2109 Cedar Street

COMMISSION OF ARCHITECTURAL REVIEW

APPLICATION FOR CERTIFICATE OF APPROPRIATENESS

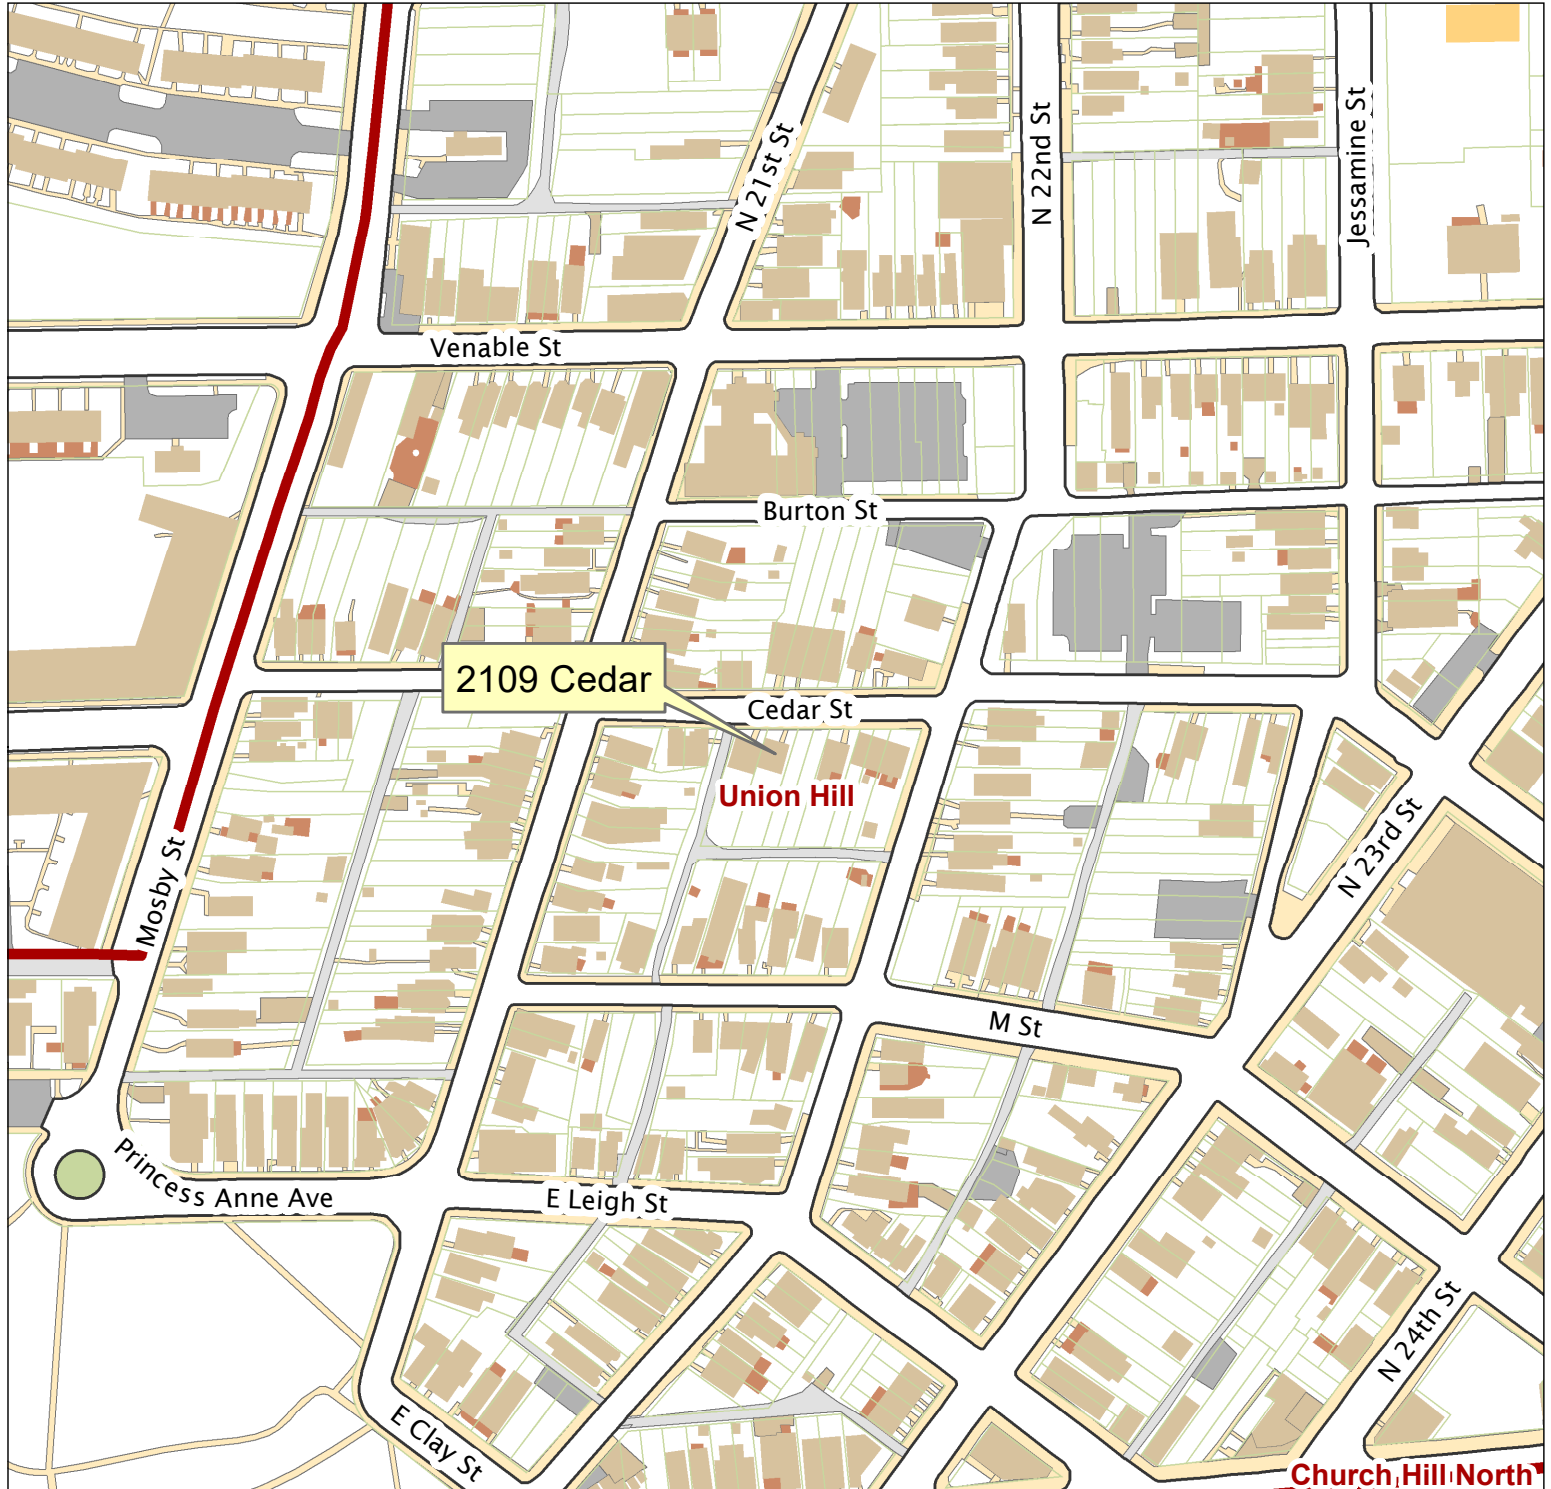
The applicant proposes to construct a two-story 1,400 square foot addition on the rear of a 1,500 square foot dwelling. The construction of the addition requires the removal of the one-story, shed-roofed extension and the plans indicate that the entire rear wall at the second story is being removed. The side walls of the addition align with the side walls of the historic dwelling. The *Guidelines* (pg. 44, Siting #1) state that additions should be subordinate in size to their main buildings and as inconspicuous as possible. Locating additions at the rear or on the least visible side of a building is preferred. The *Guidelines* (pg. 45, Materials & Colors, #1) further state that additions should not obscure or destroy original architectural elements. Finally, the *Standards for Rehabilitation* (pg. 5, #9) states that new additions, exterior alterations or related new construction shall not destroy historic materials that characterize the property. The new work shall be differentiated from the old and shall be compatible with the massing, size, scale

and architectural features to protect the historic integrity of the property and its environment.

The addition as currently designed is located at the rear of the historic building on the least visible side but it is not subordinate in size or differentiated from the historic building. The proposed new construction also results in the loss of two historic chimneys, a rear extension and the historic rear wall at the second floor. Staff recommends that the historic chimneys be retained and that the addition be inset at least a foot from the side walls of the historic dwelling. The addition can be further differentiated by the use of a different light pattern in the windows as stated above.
